Department of Planning and Zoning

TO: Development Review Board
FROM: Scott Gustin *SG*
DATE: August 6, 2013
RE: 14-0026SP; 112-114 Archibald Street

Request: Sketch plan review of major Planned Unit Development for 42 dwelling units and associated site infrastructure and demolition of existing buildings.

PROPOSED SITE PLAN
 Scale: 1" = 20 ft
 0 30 60 90 FT

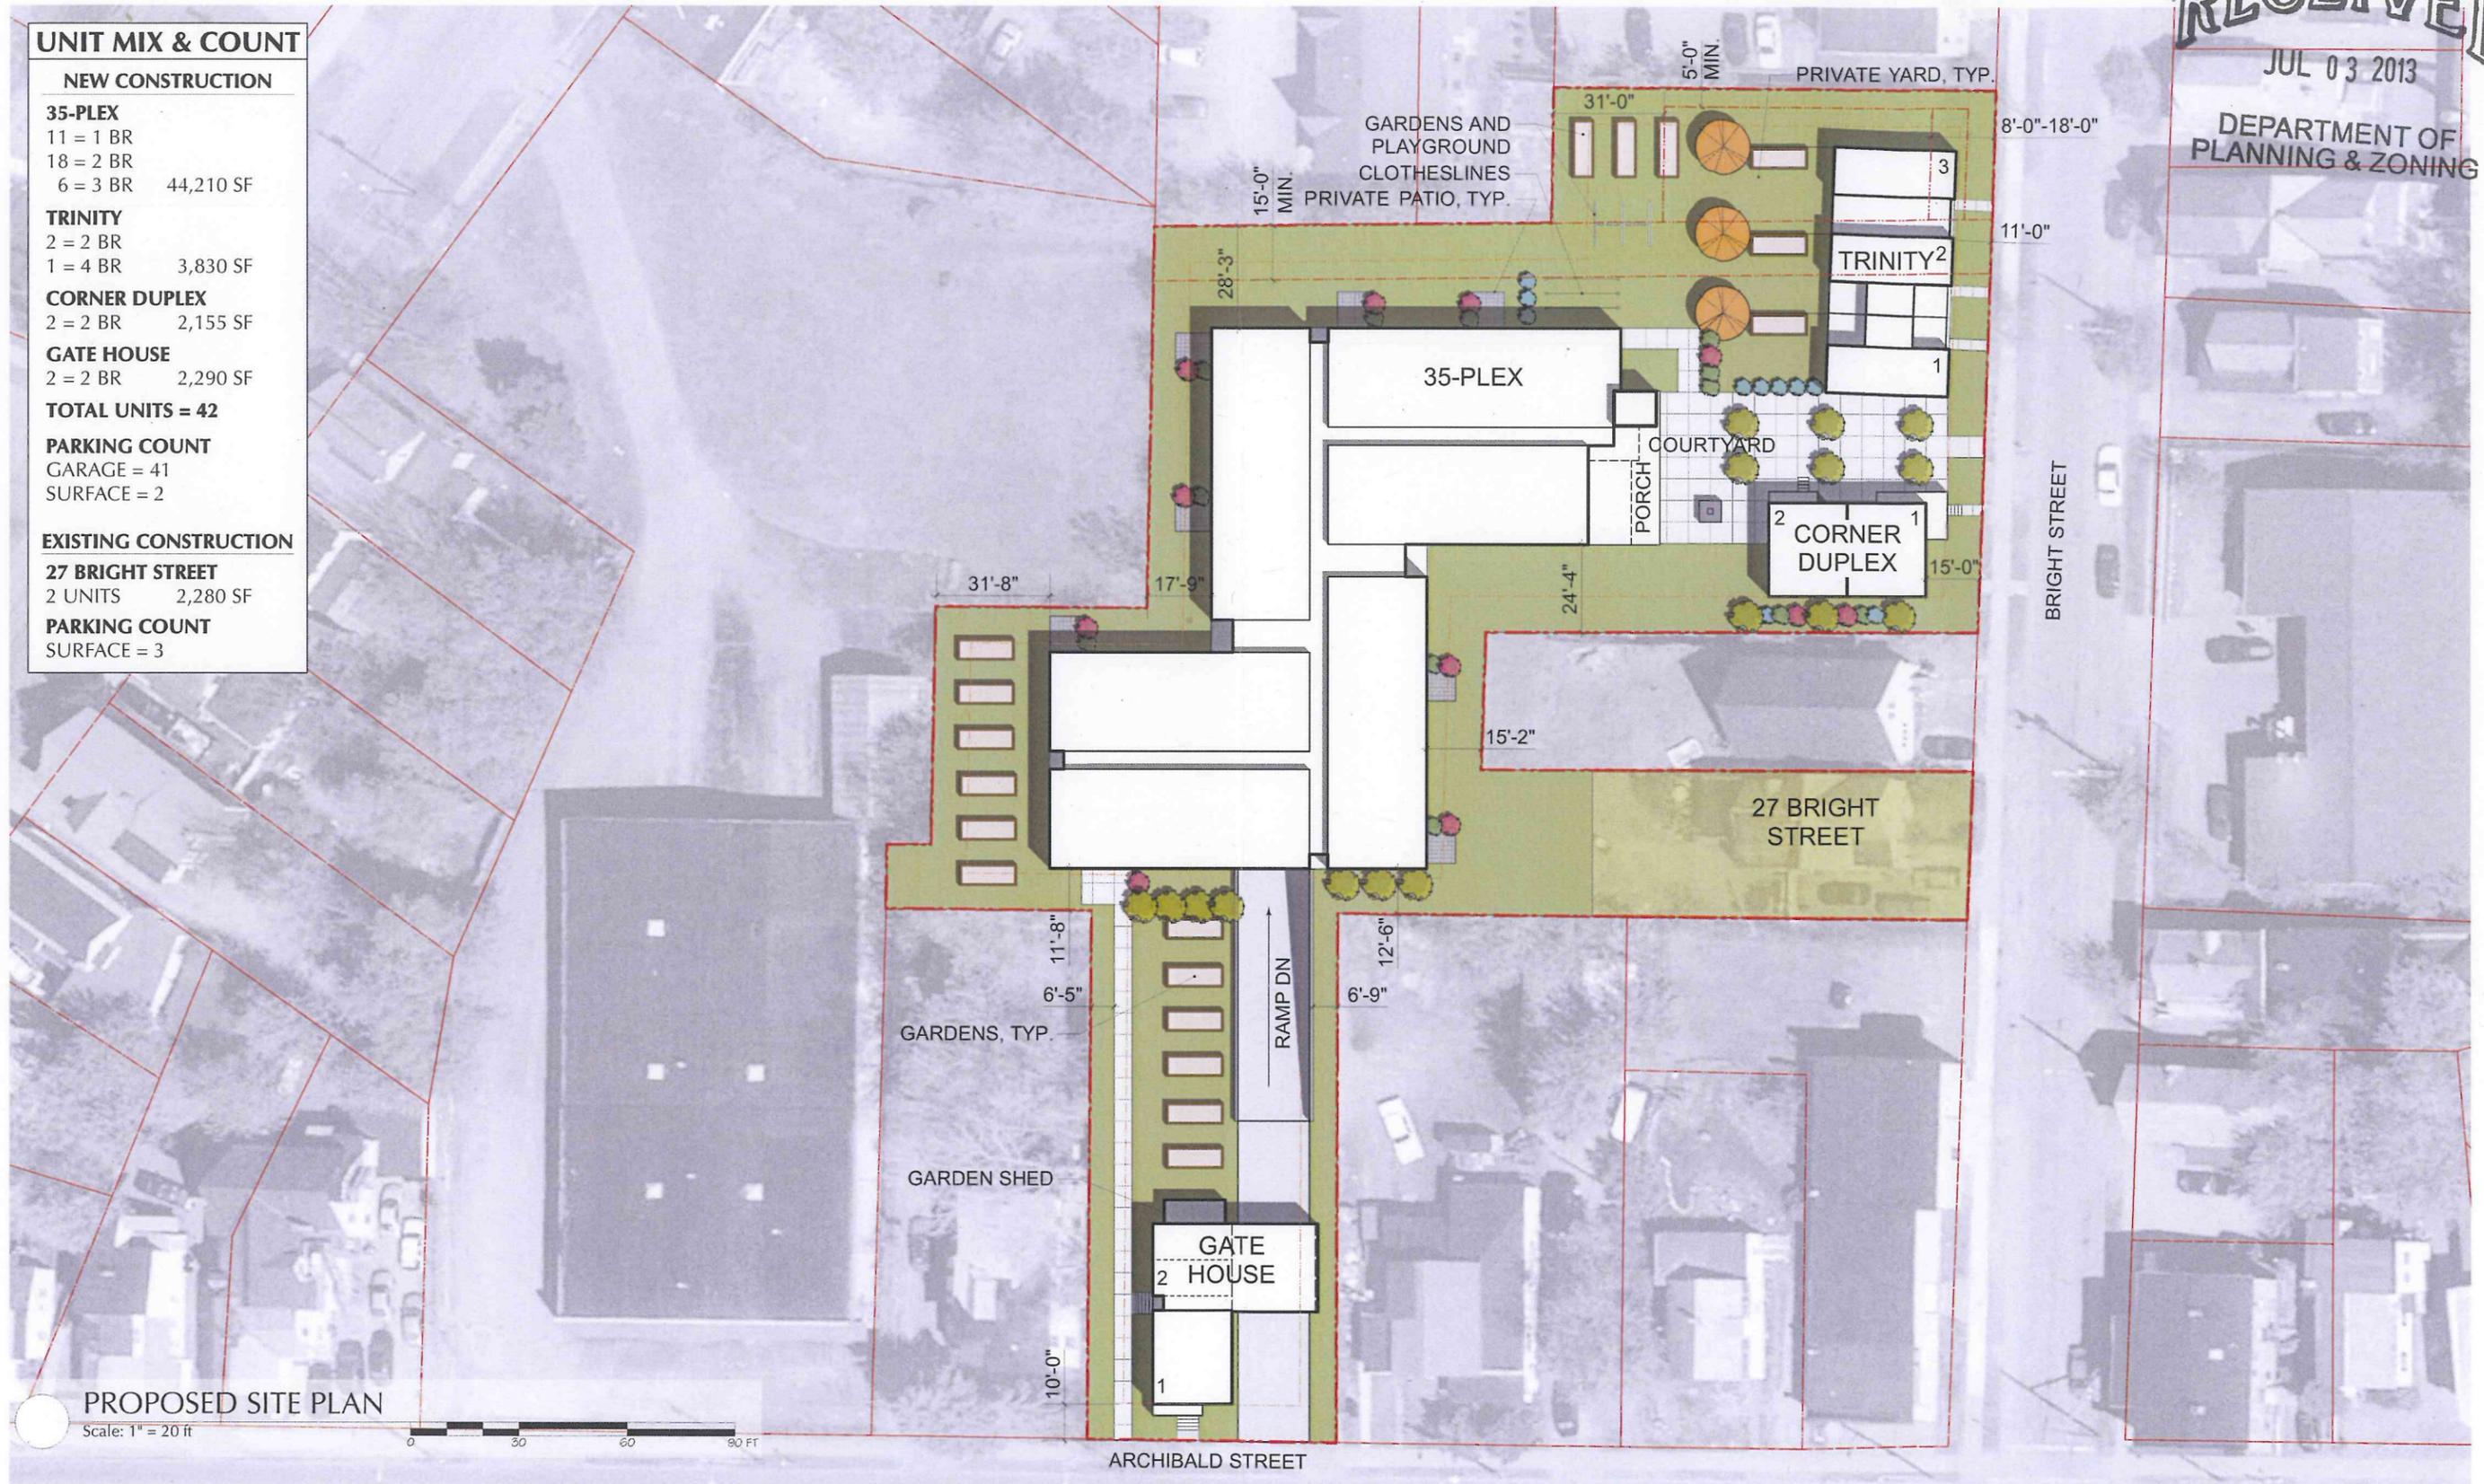
Only two setbacks apply to the NMU portion of the proposed development: 1) a 10' setback from the street curb and a 15' district setback along the NMU/RM boundary. The sketch plans depict acceptable street curb setbacks. The development does not, however, comply with the 15' RM/NMU district boundary setback. As noted previously, the applicant will likely pursue a zone change to enable the proposed design. Without a zone change, the so-called "Trinity" building

must be reconfigured to comply with a 15' district boundary setback, and any development on the small RM portion must comply with RM dimensional and density standards.

Proposed lot coverage is surprisingly minimal at 43%. The maximum permissible is 80%.

Building height is not specified on the sketch plans. The minimum height is 20' and two stories. The maximum height is up to 45' with bonuses.

One vehicular access point, from Archibald Street, will be provided into the site. A curb cut and driveway exist under current conditions but will be modified to accommodate the proposed development. Adequate access for emergency vehicles and fire apparatus must also be assured.

All of the new street edge buildings have front walkways that connect to the public sidewalk system. The interior building will connect to the public sidewalk system via new interior walkways. The newly modified driveway appears to preserve the continuity of the public sidewalk across it.

No new surface parking is proposed. All new parking will be located under the central building. Details have not yet been provided, so the sufficiency of interior circulation cannot be assessed. Bicycle parking details have not yet been provided.

Some basic landscaping is depicted on the sketch plans. Several new trees are proposed within the Bright Street courtyard. A number of clustered shrubs are proposed for screening and buffering. Ample garden space will be provided in the form of raised beds throughout the project site. A detailed landscaping plan will be required with preliminary plat.

No public plazas or open space are depicted on the sketch plans. While substantial open space remains, it will be for the use of onsite residents. Similarly, a significant courtyard is proposed near Bright Street, but it will be for use primarily by resident occupants. It will have ample eastern and southern exposure to the sun with shading provided by new trees and neighboring buildings.

The subject property is located in the shared use parking district. As a result, each dwelling unit requires 1 parking space for a total of 42 spaces. The sketch plans note a total of 43 parking spaces.

PROPOSED SITE PLAN
Scale: 1" = 40 ft

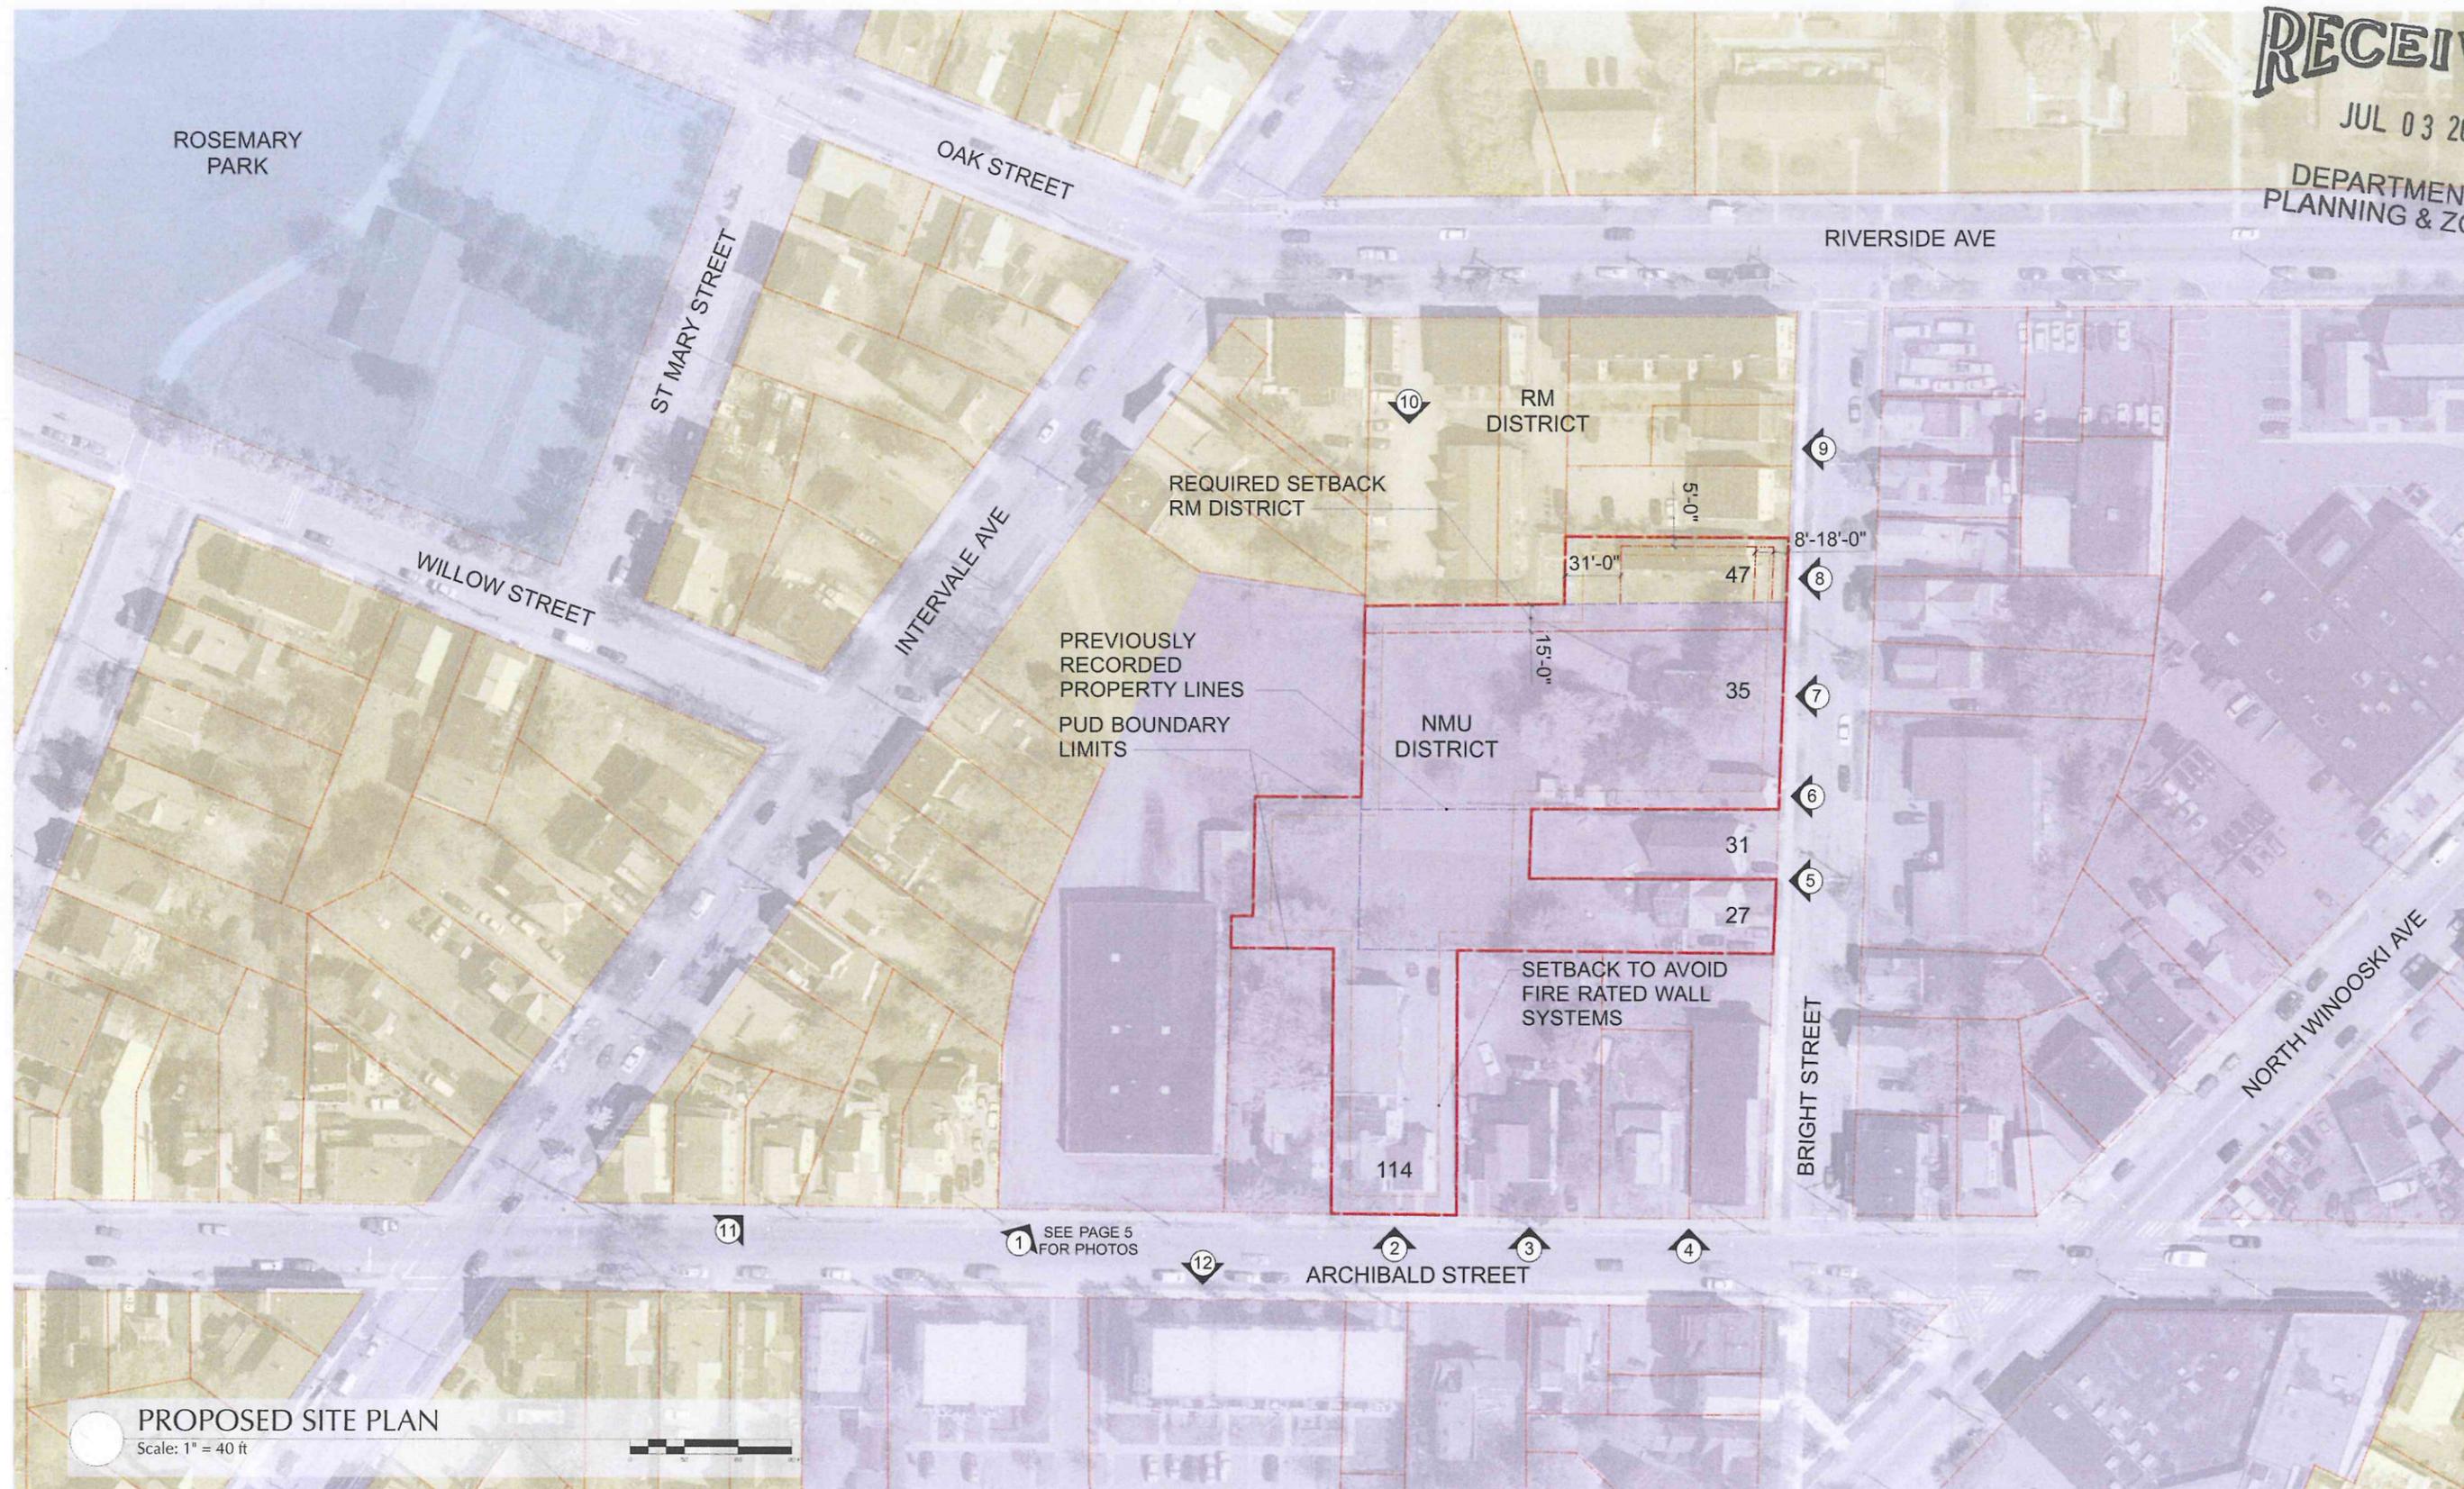
At this stage, architectural plans are limited to a massing model from a couple of perspectives. Generally, the scale, massing, and height of the smaller street front buildings are acceptable and consistent with the surrounding built environment. As noted previously, the center building is substantially larger. Its location within the interior of the property provides a degree of mitigation for its perceived mass and scale. Sensitive design will be needed in order to future break down the overall massing into smaller components consistent with the scale of neighboring development.
